METROPOLITAN GOVERNMENT OF NASHVILLE AND DAVIDSON COUNTY

STAFF RECOMMENDATION 912 Chicamauga Avenue March 19, 2014

Application: New construction—addition
District: Greenwood Neighborhood Conservation Zoning Overlay
Council District: 06
Map and Parcel Number: 08208031200
Applicant: Mark Lynn, architect
Project Lead: Paul Hoffman, paul.hoffman@nashville.gov

<p>Description of Project: The applicant proposes a rear addition to an existing contributing home.</p> <p>Recommendation Summary: Staff recommends approval of the addition to 912 Chicamauga with the conditions that:</p> <ul style="list-style-type: none">• The ridge of the addition be at least six inches (6”) below the existing ridge;• Staff approve the windows and doors; and,• Staff approve the location of the HVAC. <p>Staff finds that the proposed construction meets Section II.B.1 and II.B.2 of the Greenwood Neighborhood Conservation Zoning District Design Guidelines.</p>	<p>Attachments A: Photographs B: Site Plan C: Elevations</p>
--	--

SITE PLAN

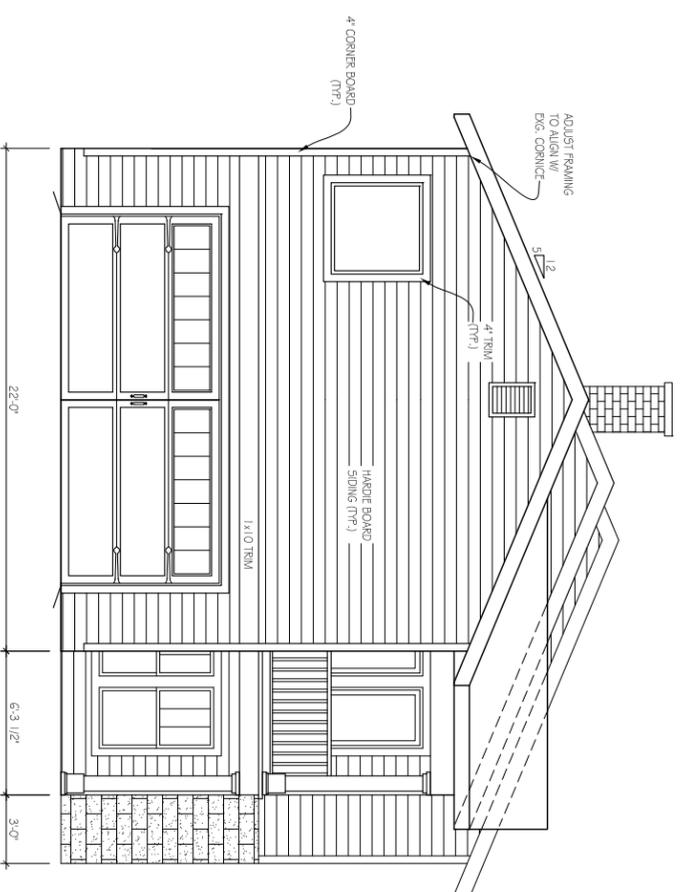
Setback & Rhythm of Spacing: The addition will be twenty-three feet ten inches (23'10") from the rear property line and five feet four inches (5'4") and eight feet (8') from the right and left property lines, respectively. It meets zoning requirements of twenty feet (20') at the rear and five feet (5') at the sides. The project meets section II.B.1.c and II.B.2.

FRONT ELEVATION

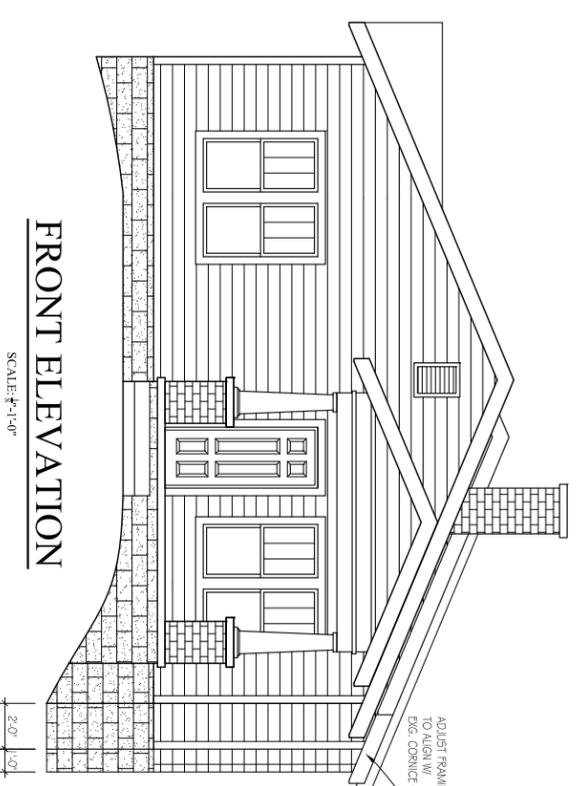
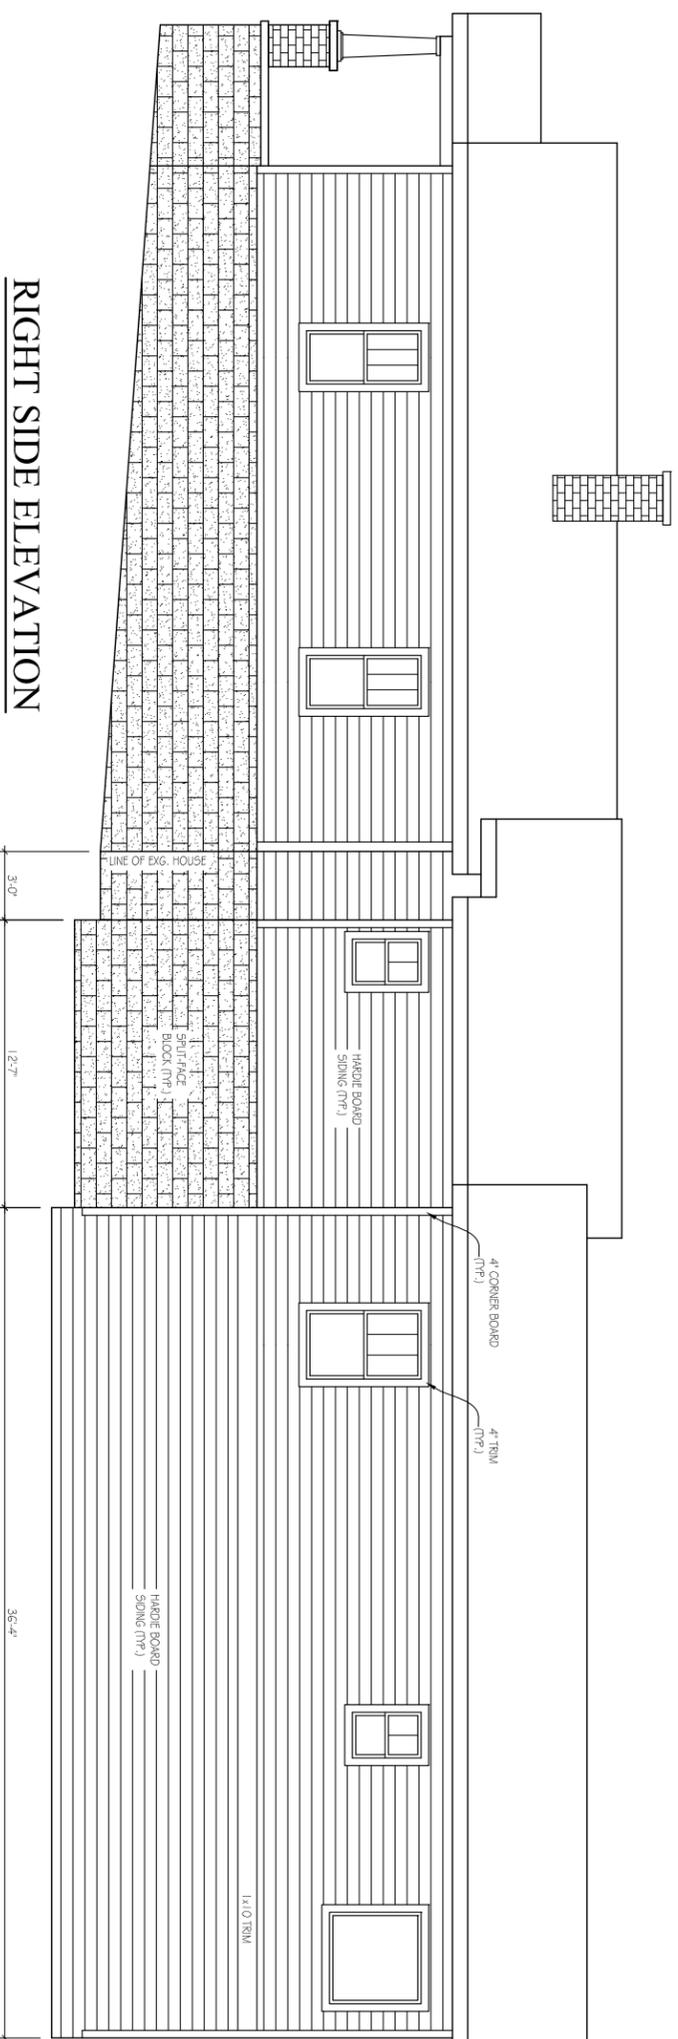
The addition's foundation height and eave height will match those of the house. Drawings indicate the addition will meet the house two inches (2") below the existing ridge. Staff recommends the addition meet the existing roof at least six inches (6") below the existing ridge. The addition will be no taller than the house. The project meets sections II.B.1.a and b. and II.B.2.

- The ridge of the addition be at least six inches (6") below the existing ridge;
- Staff approve the windows and doors; and,
- Staff approve the location of the HVAC.

RIGHT SIDE ELEVATION

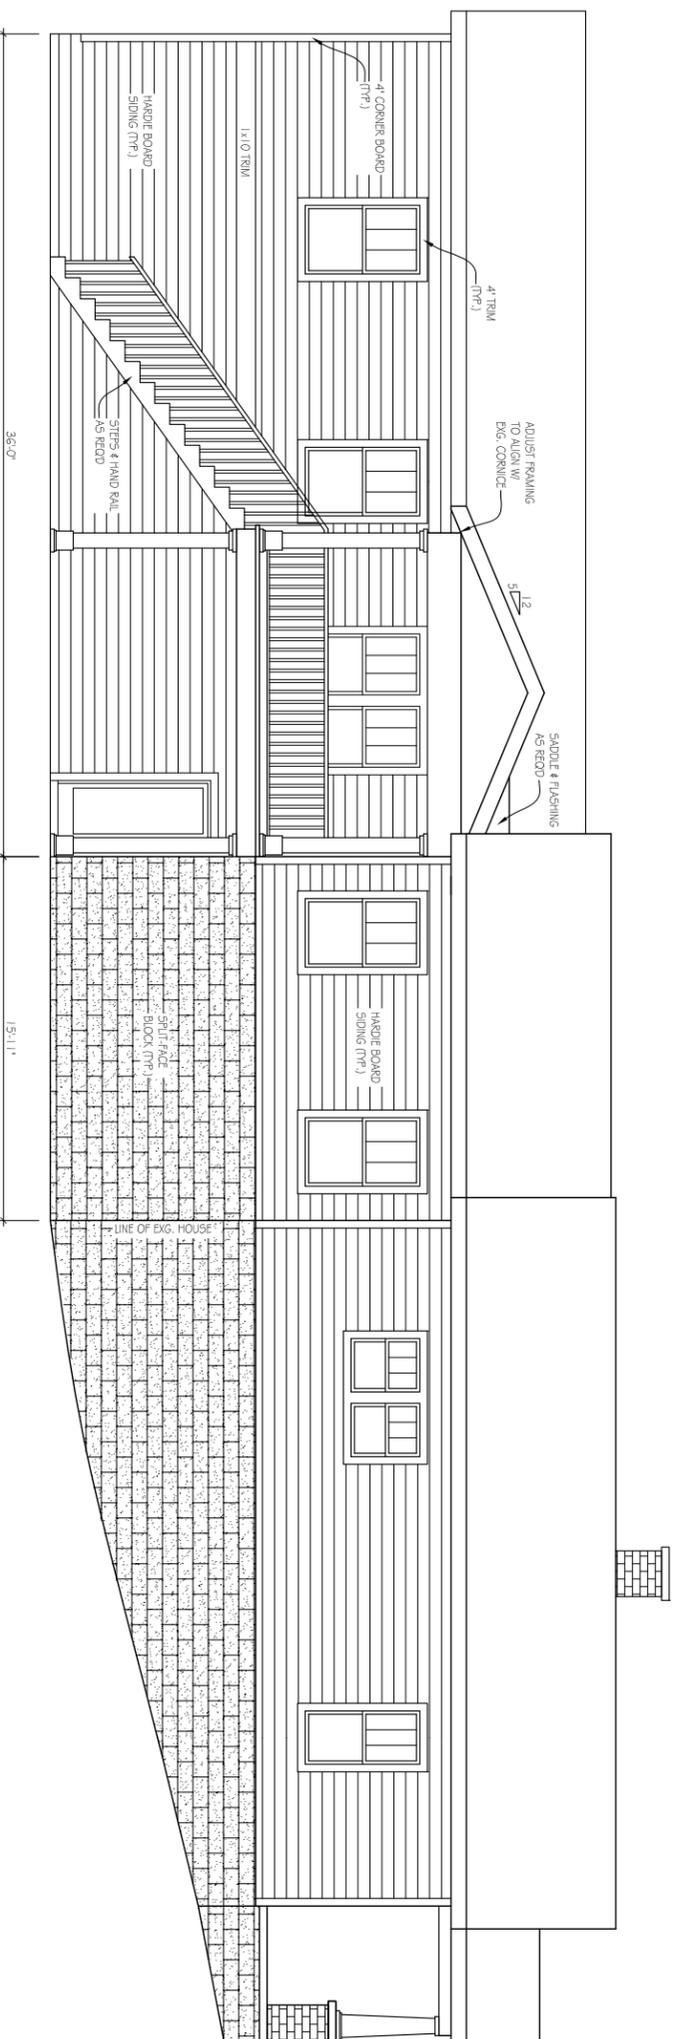
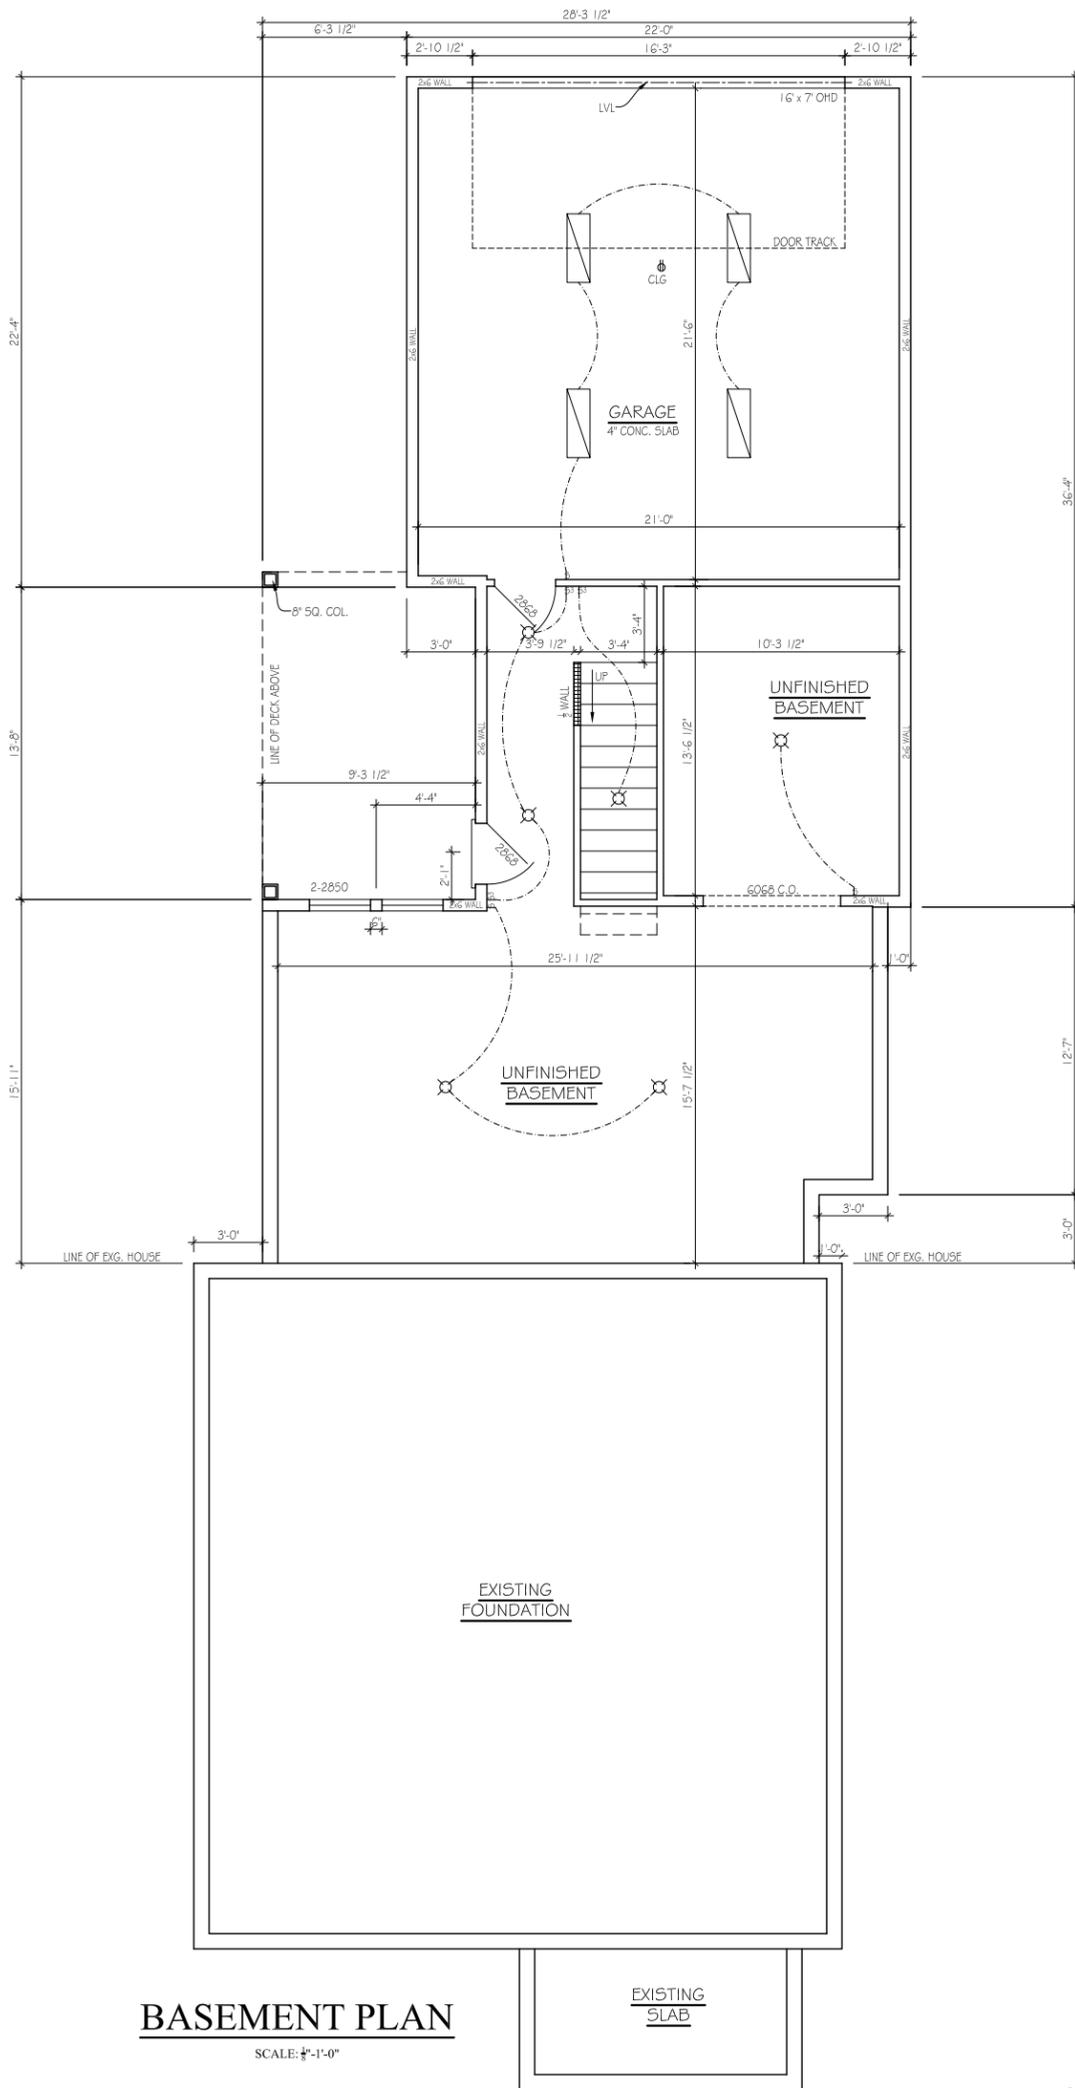
Height & Scale: The addition is inset on three feet on the left and one foot on the right, which is an appropriate setback for this one and one-half story addition. The addition will step back out twice to be a total of three feet (3') wider than the house. This is appropriate in this instance because the house is less than thirty-feet wide (30') and the increased width does not happen until thirty-three feet (33') behind the front wall. The design guidelines specifically allow for rear additions that are wider than the original house when the building is narrower than 30' or shifted to one side of the lot.

Proportion and Rhythm of Openings: No changes to the window and door openings on the house were indicated. The windows on the proposed addition are all generally twice as tall as they are wide, thereby meeting the historic proportions of openings. There is an expanse of approximately fourteen feet (14') between windows on the right elevation, and approximately sixteen feet (16') on the rear elevation; as these locations are at the rear of the addition over the garage and are minimally visible, staff finds them to be appropriate. Staff finds the project's proportion and rhythm of openings to meet section II.B.1.g and II.B.2.
